ITEM-3 **POST EXHIBITION - PLANNING PROPOSAL, DRAFT DCP AND DRAFT VPA - 55 COONARA AVENUE, WEST PENNANT HILLS (1/2018/PLP)**

ITEM-3	POST EXHIBITION - PLANNING PROPOSAL, DRAFT DCP AND DRAFT VPA - 55 COONARA AVENUE, WEST PENNANT HILLS (1/2018/PLP)
THEME:	Shaping Growth.
OUTCOME:	5 Well planned and liveable neighbourhoods that meets growth targets and maintains amenity.
STRATEGY:	5.1 The Shire's natural and built environment is well managed through strategic land use and urban planning that reflects our values and aspirations.
MEETING DATE:	26 NOVEMBER 2019 COUNCIL MEETING
GROUP:	SHIRE STRATEGY, TRANSFORMATION AND SOLUTIONS
AUTHOR:	MANAGER – FORWARD PLANNING NICHOLAS CARLTON
RESPONSIBLE OFFICER:	GROUP MANAGER – SHIRE STRATEGY, TRANSFORMATION & SOLUTIONS DAVID REYNOLDS

This report recommends that the planning proposal to rezone land at 55 Coonara Avenue, West Pennant Hills be forwarded to the Department of Planning, Industry and Environment for finalisation. It is also recommended that Council adopt the associated site-specific Development Control Plan ('DCP') and execute the draft Voluntary Planning Agreement ('VPA') which secures contributions towards local infrastructure arising f

Figure 5

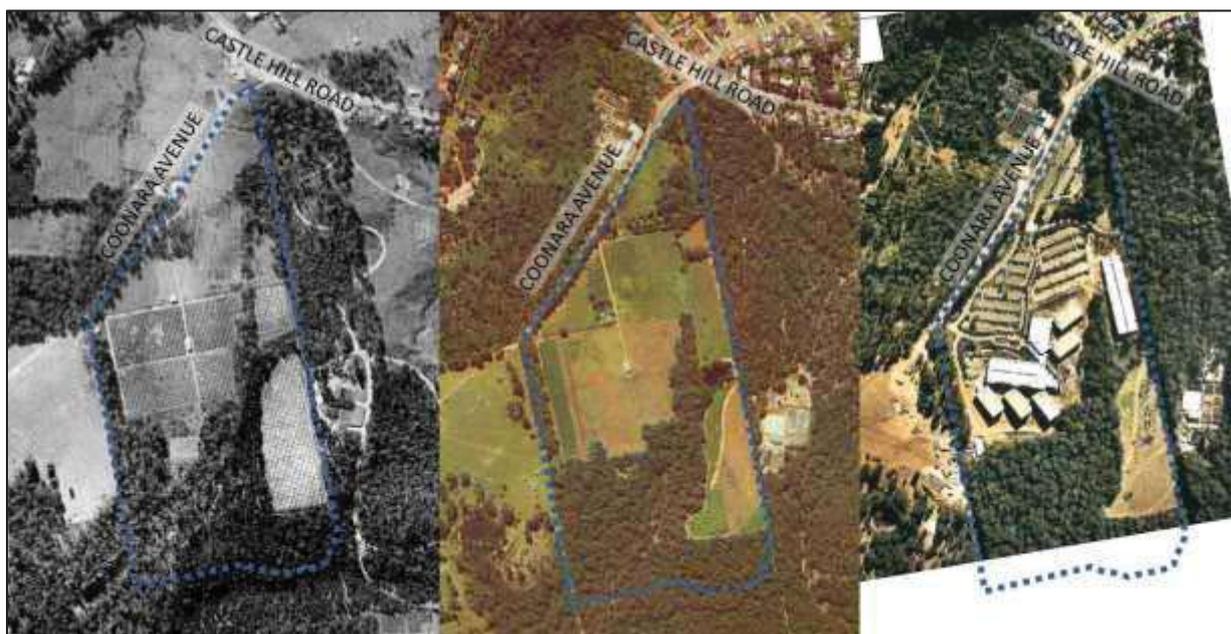
The proponent has supported the proposal with detailed environmental reports prepared by Keystone Ecological. It is considered that the Proponent has utilised an ‘avoid, minimise, offset’ approach, as required by the Biodiversity Conservation Act, with respect to potential impacts on BGHF and STIF. In particular, the proposed development footprint has been determined by the Proponent on the basis of avoiding ecologically valuable areas (riparian areas, threatened species habitat and natural remnant bushland - excluding areas of replanting associated with existing IBM development) and concentrating activity to areas already disturbed by the existing development footprint, car park and areas that were cleared for previous development to occur on the site (refer to Figure 5 below).

Figure 6

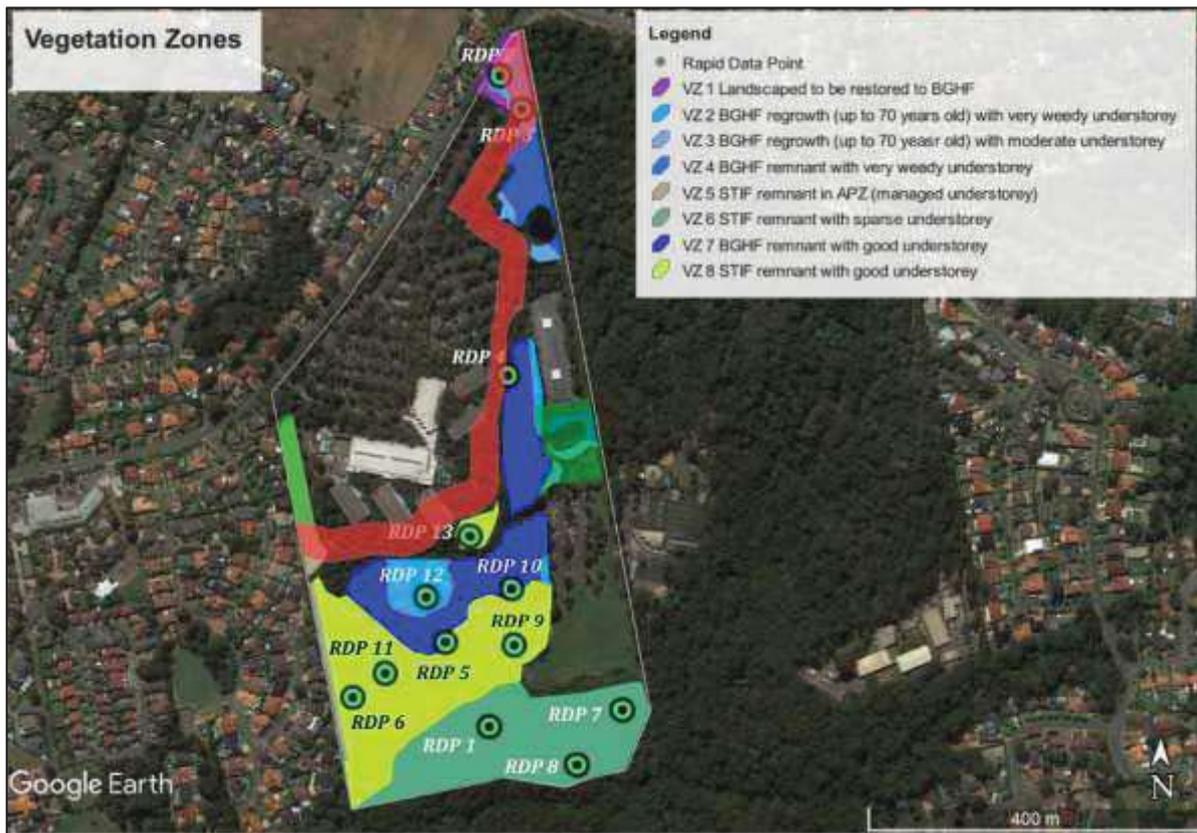
In response to EES' submission, the Proponent has provided additional information which identifies the indicative areas of APZ in relation to mapped areas of BGHF and STIF. As indicated below, the APZ is located primarily outside of the key areas of the site containing valuable remnant STIF and BGHF communities and the Proponent has generally sought to avoid impacts on remnant vegetation.

Figure 7
Vegetation type mapping

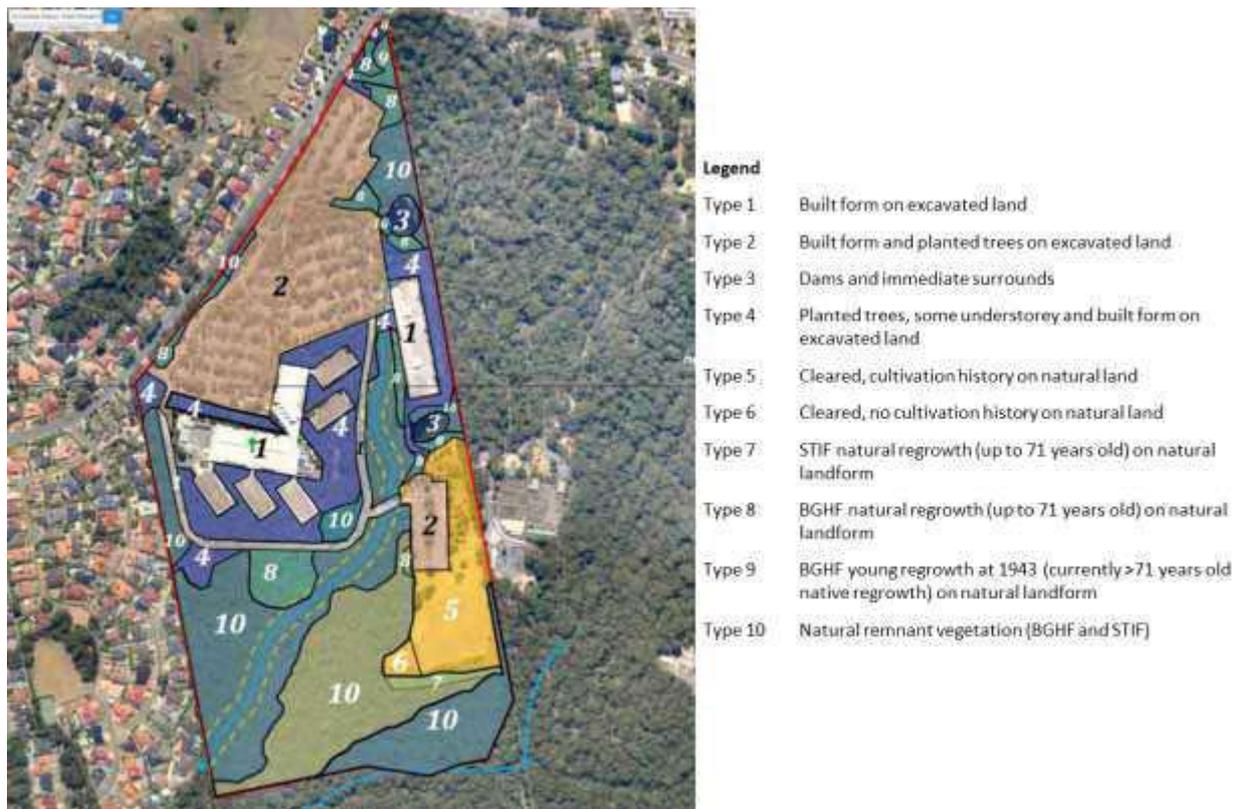
The Proponent’s Biodiversity Assessment includes a map of the preliminary flora and fauna surveys which categorises the site into 10 categories. Land identified as ‘10’ has the highest significance, being natural remnant vegetation, likely comprising the BGHF and STIF communities.

With respect to existing vegetation within the carparks, the proponent’s ecologist advises that these trees are not naturally occurring and do not represent Blue Gum High Forest. Instead, they advise that the carpark is overwhelmingly dominated by Lemon-scented Gum, a species native to Queensland. This species is also known to hybridise with Sydney Blue Gum, which has the potential to “pollute” the genetic makeup of the major tree of Blue Gum High Forest. As such, the proponent’s ecologist advises that the car park plantings do not exhibit a natural forest structure.

The Proponent has used this information, along with historical aerials of areas of disturbance on the site, to reasonably inform the anticipated development footprint. It is noted that the majority of areas proposed to be subject to clearing as a result of the proposal are located within the existing development footprint or areas where the habitat has already been modified and disturbed through the existing use of the site. The Biodiversity Assessment has concluded that while there is a moderate likelihood that threatened species will occur on the site, it is highly likely that these threatened species will be located within the remnant vegetation areas that are not proposed to be disturbed by this proposal (rather than in areas already disturbed by the existing use).

While it is acknowledged that the detailed mapping of vegetation communities has not been completed as part of the planning proposal, this level of detail is required as part of the development assessment phase and the Proponent has advised that this work will be completed and a Biodiversity Development Assessment Report will be provided at the development application stage.

Figure 6: Number of Storey's in Housing Precinct

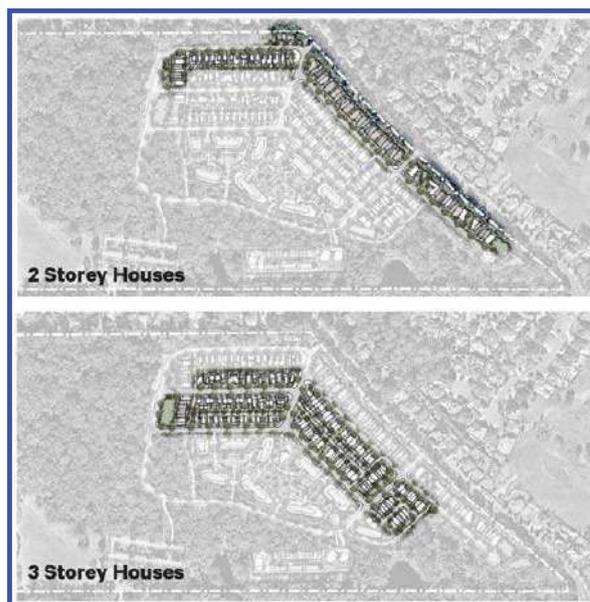
- **Section 3.3 Building Heights:** This new section has been included to ensure that a transition of heights is provided across the site, with low-scale development to be provided where there is an interface with the existing low density residential neighbourhood. New figures have been included to identify where two-storey and three-storey dwellings are expected on site, as shown in Figure 10.

- (a) The number of storeys for dwellings within the Housing Precinct is to be in accordance with Figure 6. Dwellings may incorporate split levels where required to follow the site topography.
